METROPOLITAN GOVERNMENT OF NASHVILLE AND DAVIDSON COUNTY

STAFF RECOMMENDATION
1724 4th Avenue North
December 20, 2017

Application: New construction-infill and outbuildings
District: Salemtown Neighborhood Conservation Zoning Overlay
Council District: 19
Map and Parcel Number: 08205008200
Applicant: Quirk Designs
Project Lead: Paul Hoffman; paul.hoffman@nashville.gov

Description of Project: Application for infill construction of new duplex and carports.

SITE PLAN

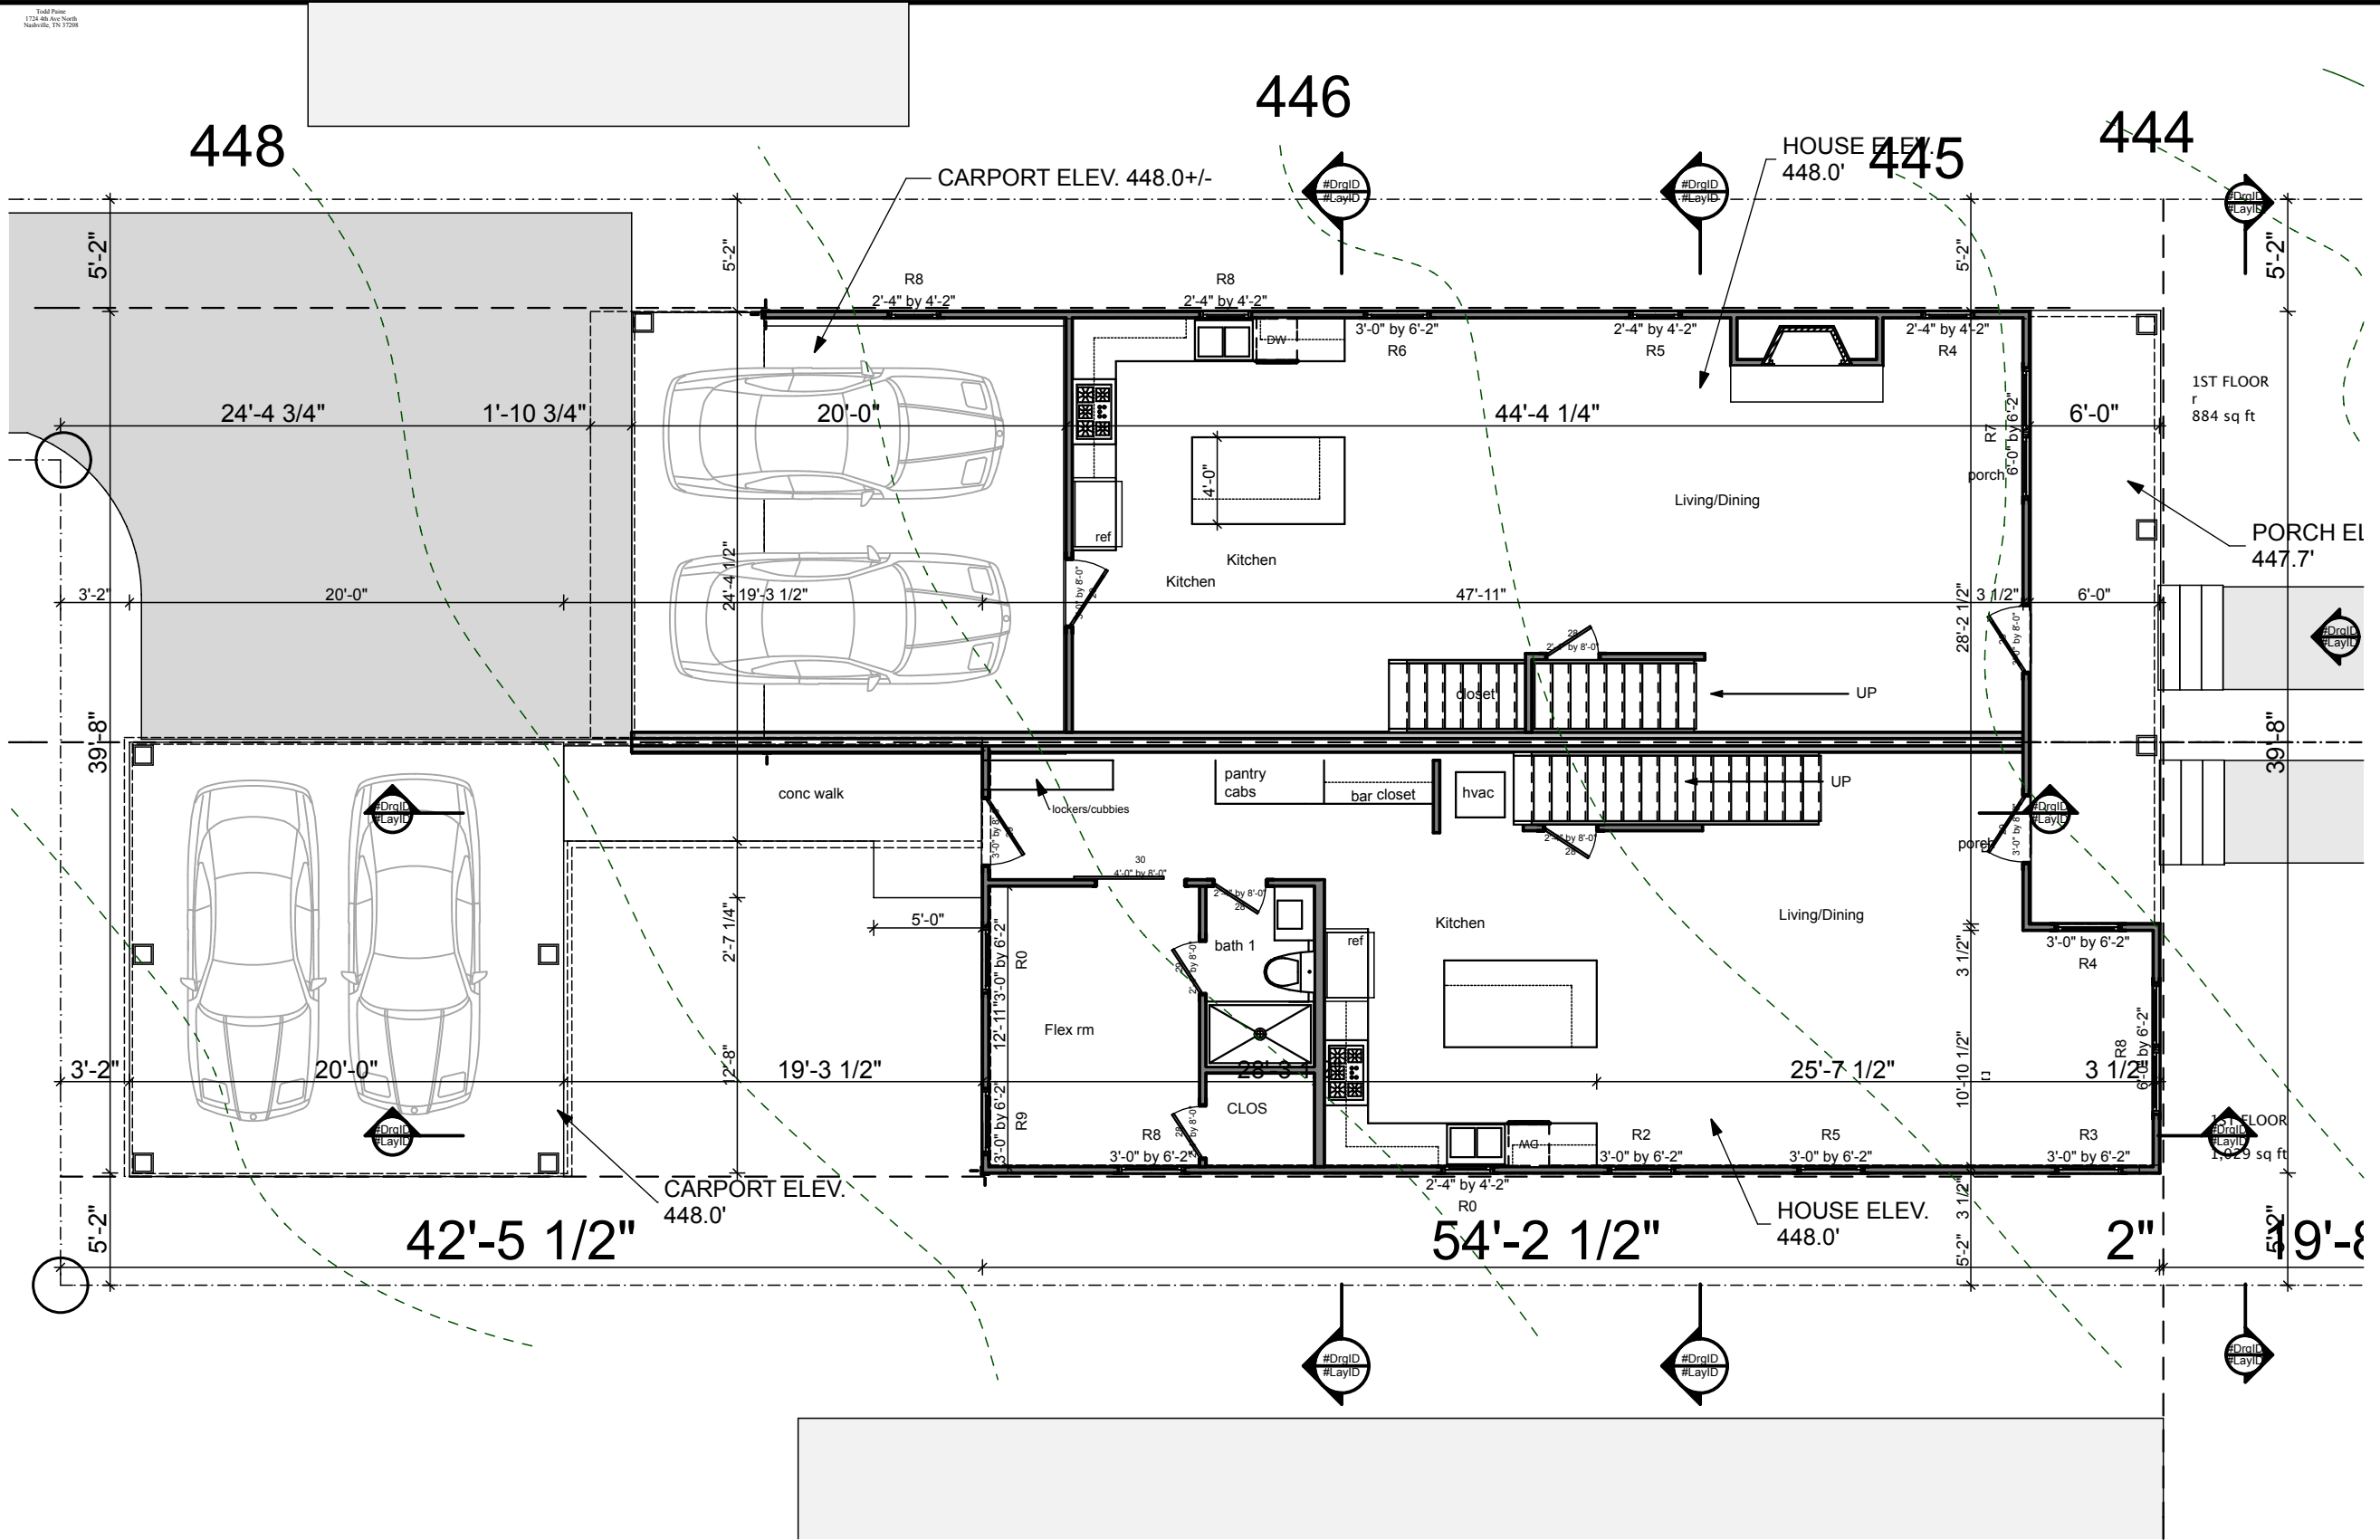
Outbuilding: The application includes an attached carport for each unit. Attached outbuildings would not normally be appropriate. However, the lot is oddly-shaped and sized, and detached outbuildings would be impracticable. In this case Staff finds the attached carport to be appropriate due to the constraints of this lot. Each outbuilding is four hundred square feet (400 sq. ft.), for a total of eight hundred square feet (800 sq. ft.)

for both. Section III.H.1 of the design guidelines limits the total size of an outbuilding to seven hundred fifty square feet (750 sq. ft.). Staff recommends as a condition of approval that the outbuildings not exceed this amount. With this condition, Staff finds that the project meets Section III.H of the design guidelines for outbuildings.

1 FRONT ELEVATION
SCALE: 1/8" = 1'-0"

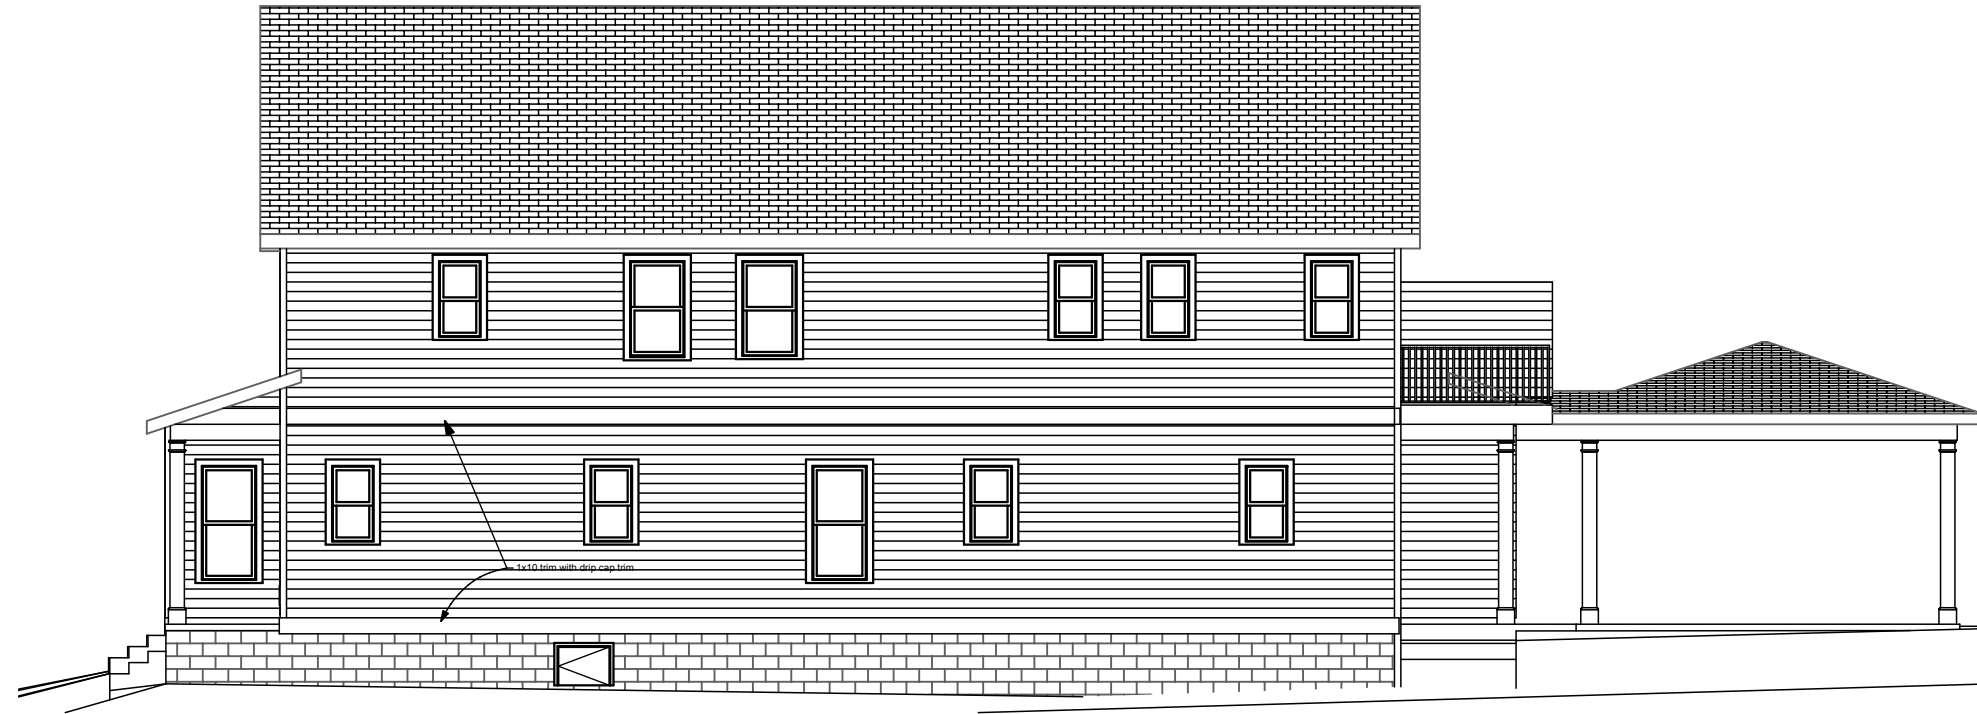
Height & Scale: The main ridge of the proposed new building has a height of thirty-four feet, ten inches (34' 10") from grade. The front-facing gable is one foot (1') higher reaching a height of thirty-five feet, ten inches (35' 10"). Section III.A of the design guidelines allows for two-story forms but states that infill should not exceed thirty-five feet (35'). Staff recommends that the height be reduced not to exceed thirty-five feet (35') at its tallest point. The eave height of the house is twenty feet (20') from the finished floor height, which is similar to that of recently-approved infill in Salemtown which has ranged from twenty to twenty-one feet (20'-21') for two-story structures. The foundation height is three feet, six inches (3'6") which is similar to the context of foundations from two to four feet (2'-4') tall and is necessary because of the rise in grade from front to back.

The new structure will be thirty-nine feet, eight inches (39' 8") wide. Contributing homes on the block are as wide as thirty-six feet (36'). Recently-approved new construction has been permitted as wide as forty feet (40'). The bay on the left side of the porch reads as an enclosed portion of the porch. As this is a feature not typically seen historically, staff recommends moving the bay to the right side, for that portion to read as a gabled-ell form under the projecting gable above it.

Figure 2. Staff recommends moving this bay to the right side to read as part of the projecting gable above

With the condition that the height of the front-facing gable is reduced to thirty-five feet (35') or less from grade, and the projecting porch bay is moved to the right side of the structure, Staff finds that the project meets Sections III. A and B for height and scale.

1. The ridge height is reduced to thirty-five feet (35’);
2. The total footprint of outbuildings reduced not to exceed seven hundred and fifty square feet (750 sq. ft.);
3. The projecting porch bay is moved to the right side of the structure;
4. The finished floor height is consistent with the finished floor heights of the adjacent historic houses, to be verified by MHZC staff in the field;
5. Staff approve the colors of the shingle and metal roof color, trim, porch materials, railings, windows and doors prior to purchase and installation; and
6. HVAC and other utilities are located behind the house or on a side facade, beyond the mid-point of the house.
